CONSTRUCTION DOCUMENTS FOR HONOR CHARTER SCHOOL

COVER SHEET

GENERAL NOTES HONOR CHARTER SCHOOL HIGHMARK SCHOOL DEVELOPMENT 8250 BEAT GRASS MEADOWS DR.							
DRAWING CW	DATE: 11/11/2024	CHECKED:	DATE:	REVISION #:	DATE:	JOB NO. C01517	
PREPARED UNDER THE SUPERVISION OF TAIT & ASSOCIATES, INC.							2 OF 48
BRIAN CAMPBELL COLORADO P.E. #40196							2/6/2024 Internal Review #1

1 OUTLET STRUCTURE DETAIL NTS

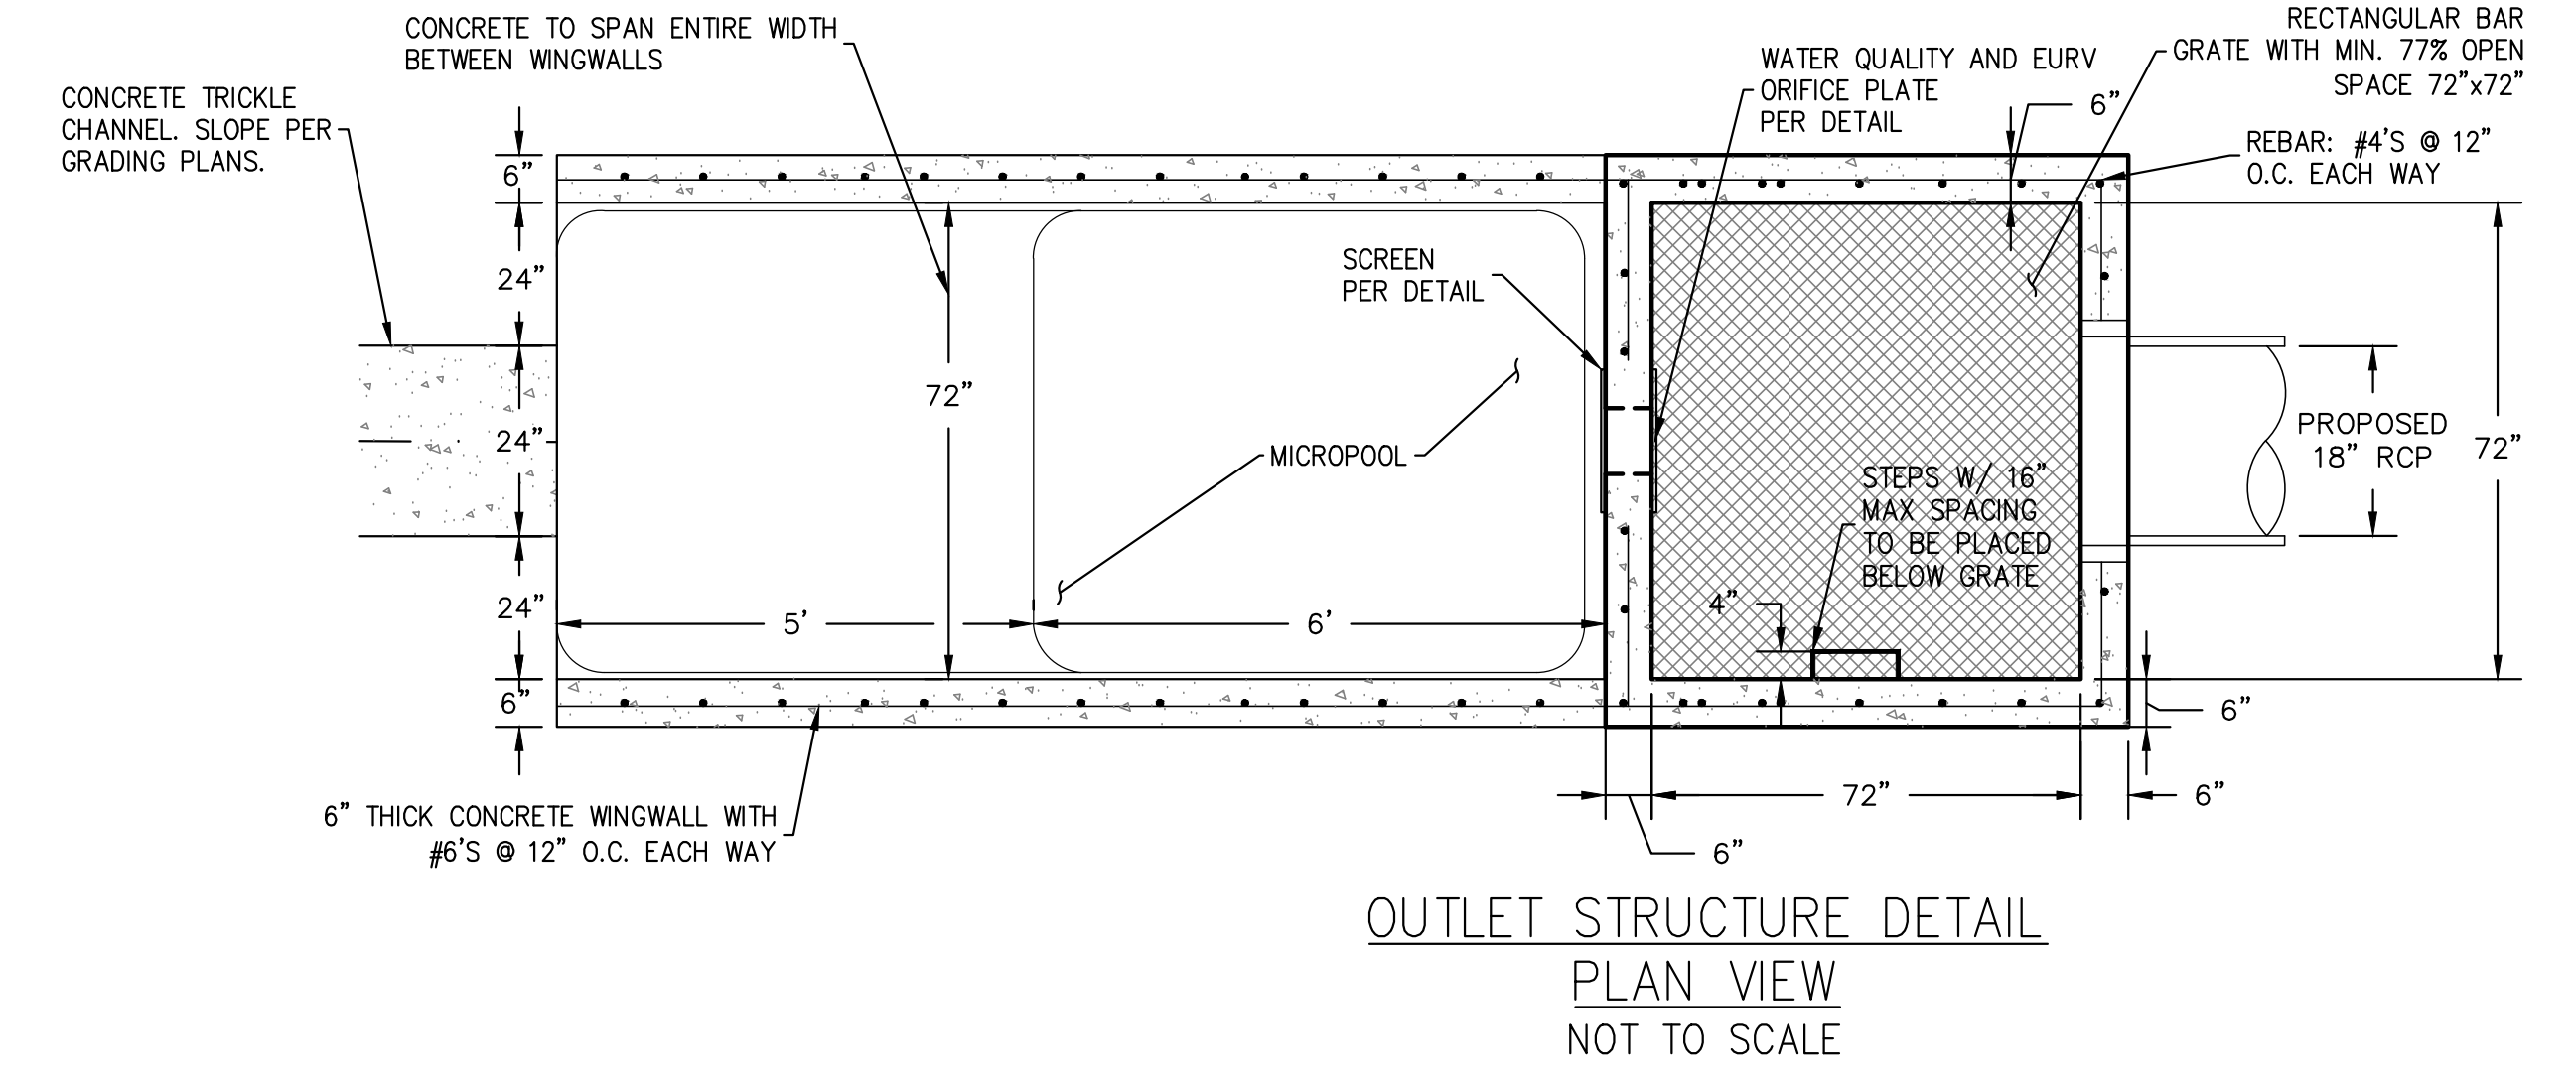
Please provide a detailed pond plan view that states the dimensions (ex: 3' concrete trickle channel, 10x8, type M riprap pad, etc.) of key pond components.

Provide centroid elevations to match the MHFD detention spreadsheet. Also please show orifice holes to scale.

Gasket: Provide detailed gasket info for between the orifice plate and concrete like thickness, width, brand/model, etc.

The gasket shall be made of 1/4-inch thick, 60 durometer EPDM rubber in a continuous sheet the size of the orifice plate. The sheet shall be placed between the orifice plate and the concrete wall, with the width of the overlap between the plate and the concrete. Openings shall be cut into the sheet corresponding to the plate bolt holes and the concrete wall opening, cuts made either by the contractor in the field or by the manufacturer. Or equivalent gasket approved by EPC. Note that caulk is not an approved equivalent and will not be accepted by EPC.

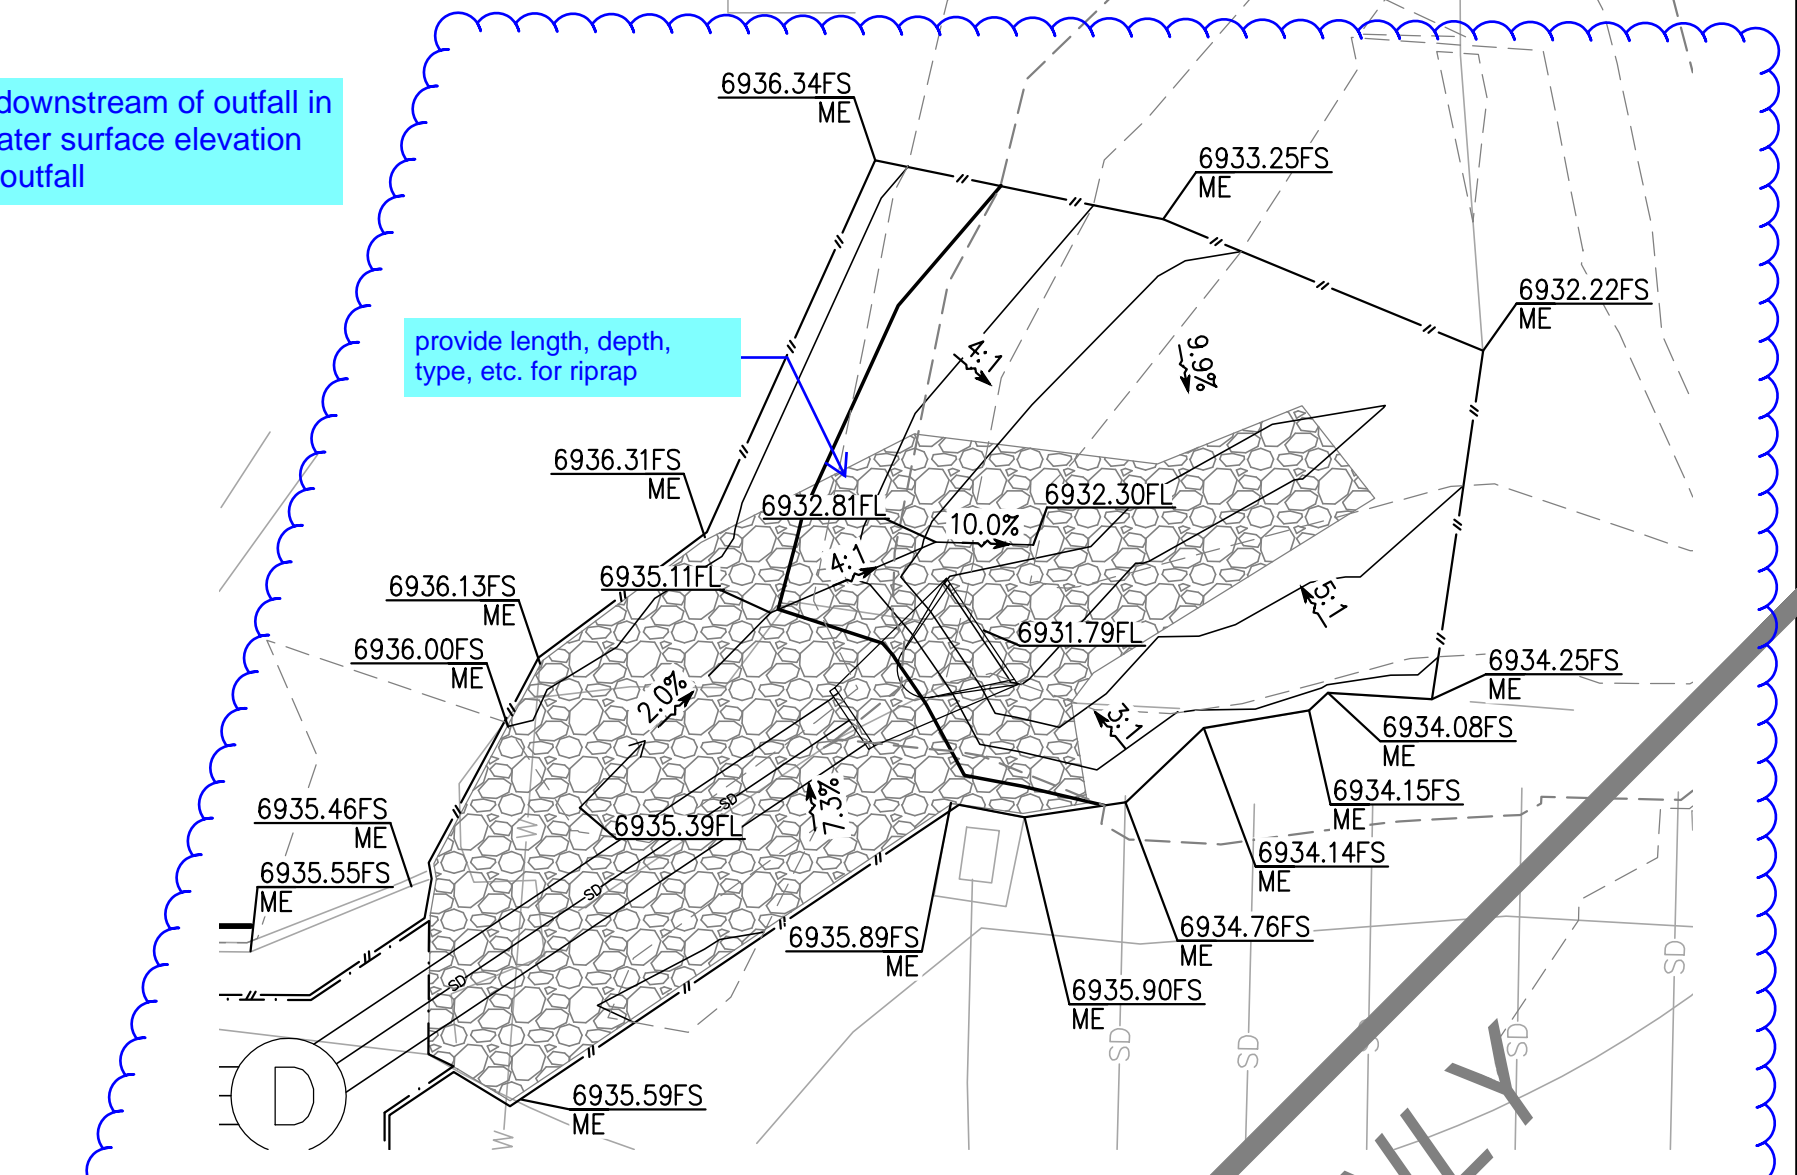
Show 200 feet downstream of outfall in profile, Q100 water surface elevation downstream of outfall

LP-1

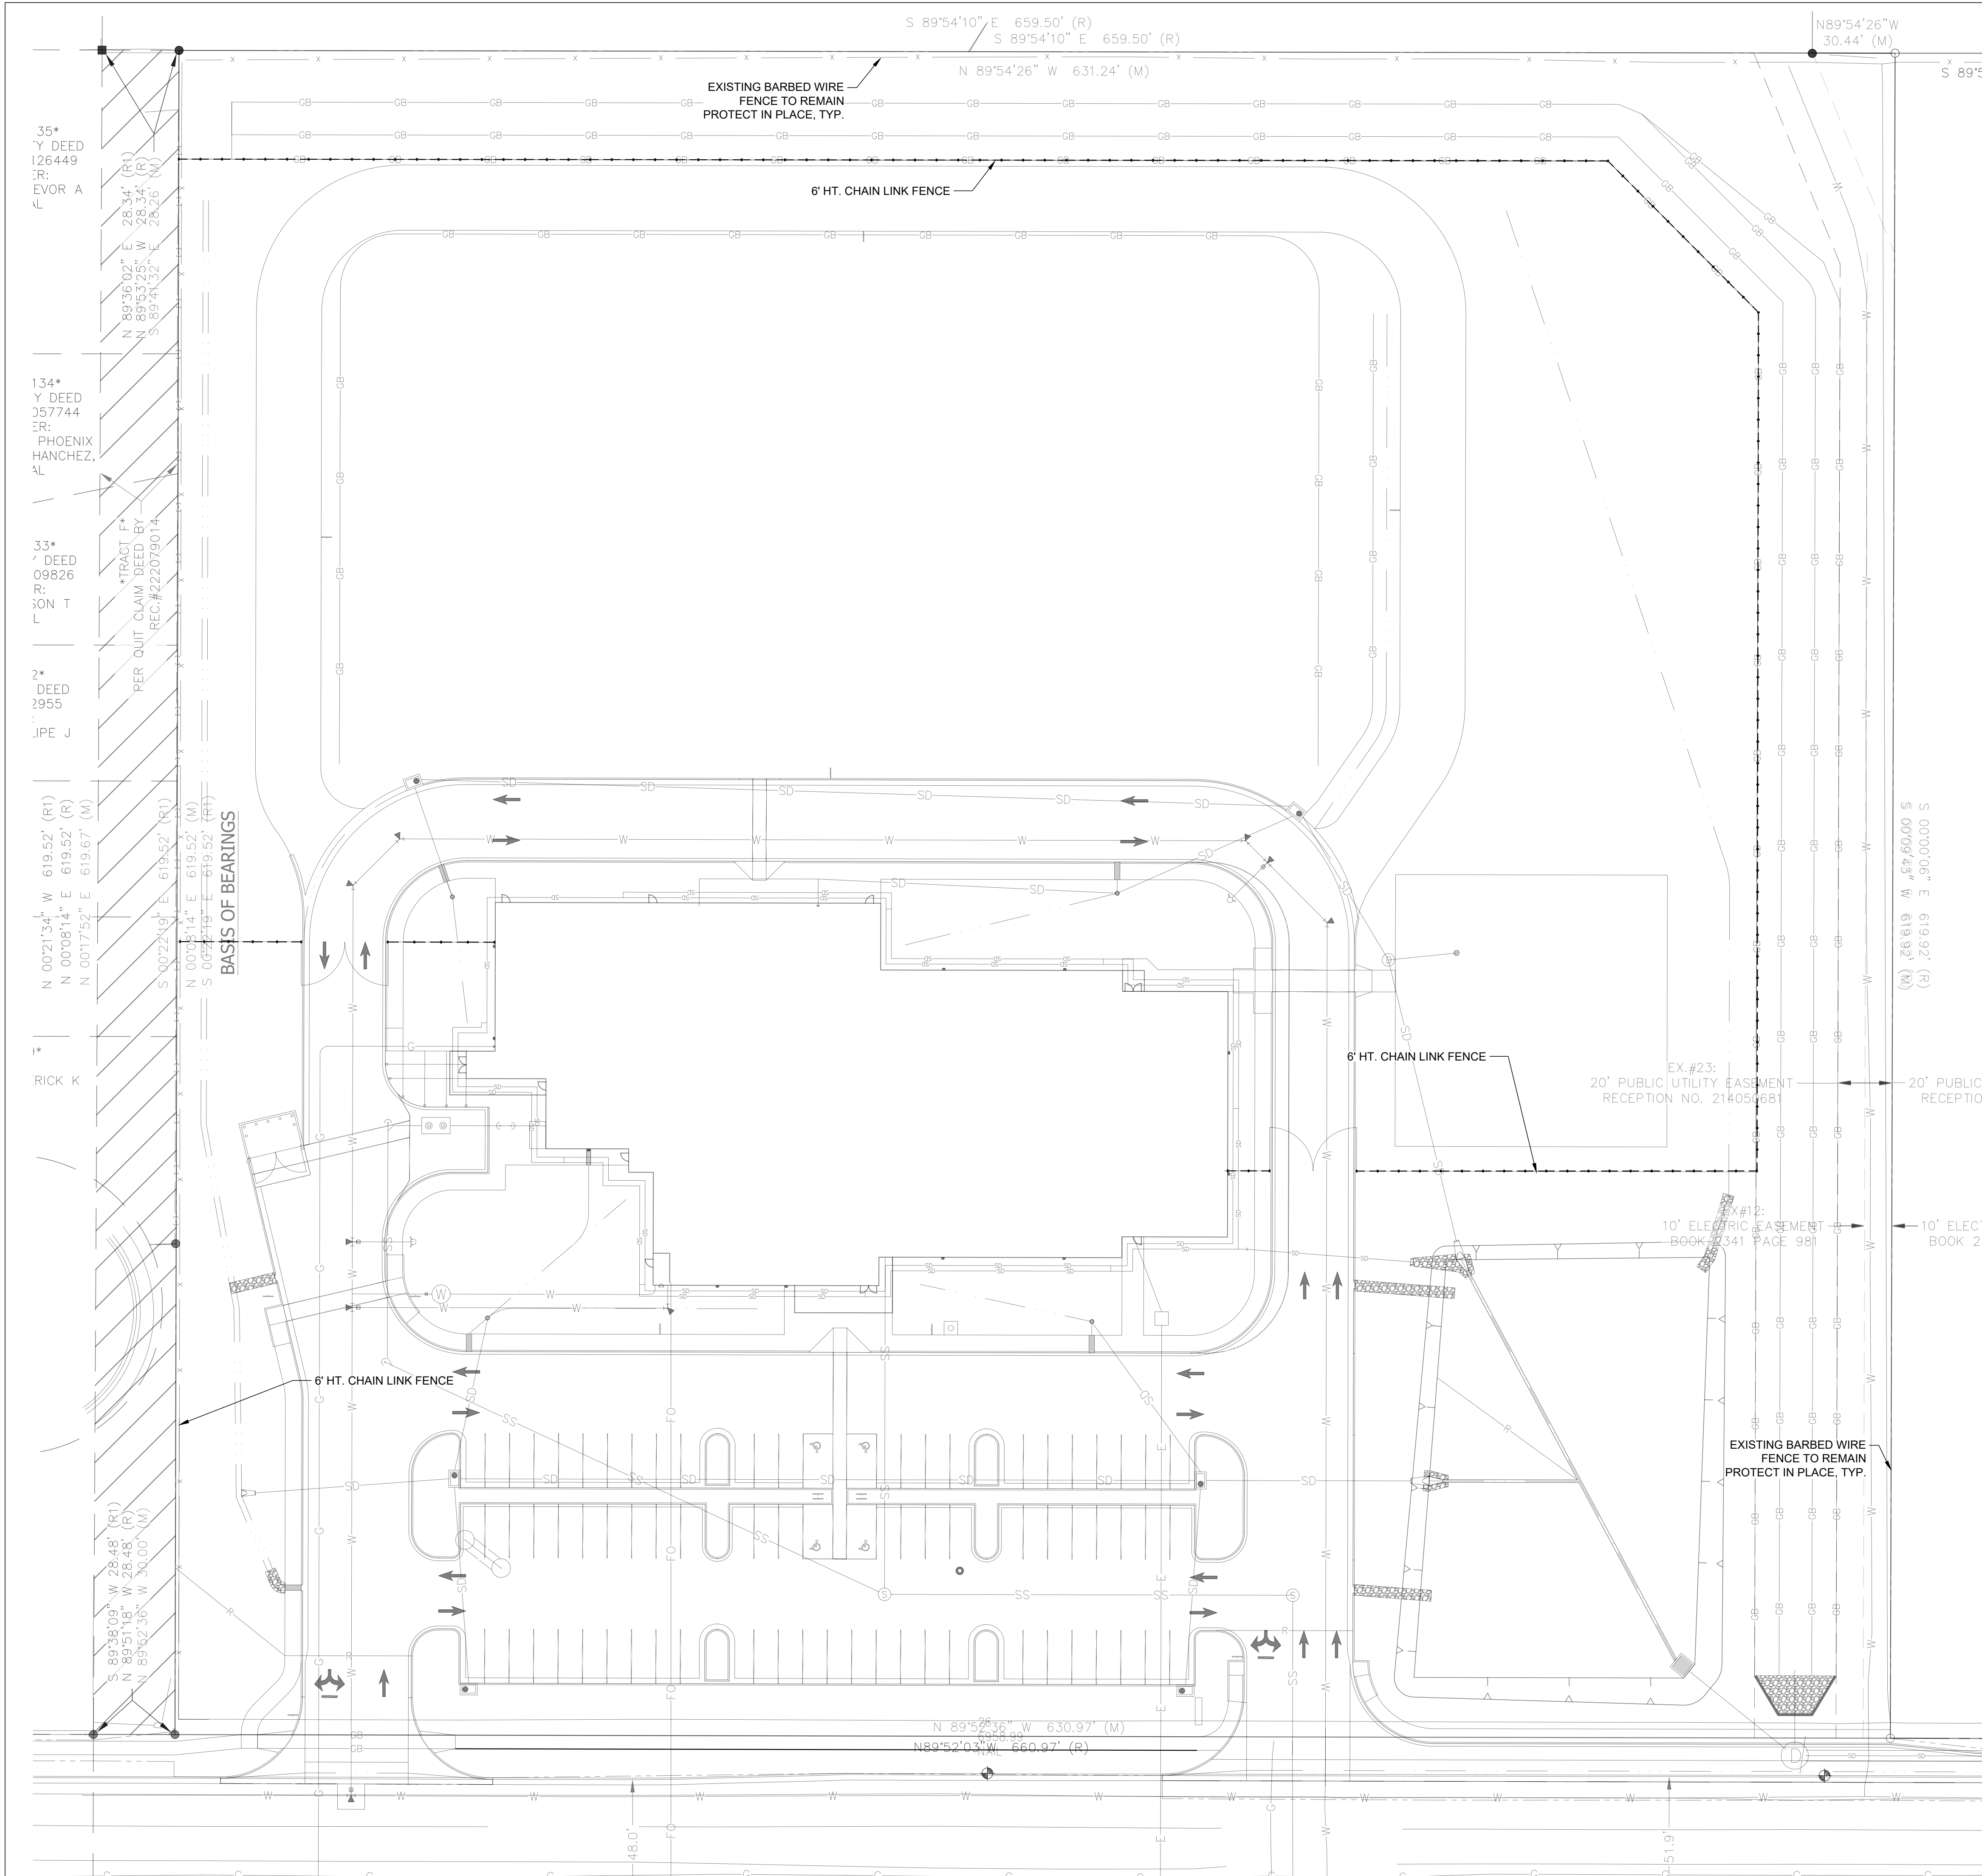
Include sight distance triangles to ensure plantings are outside of those areas
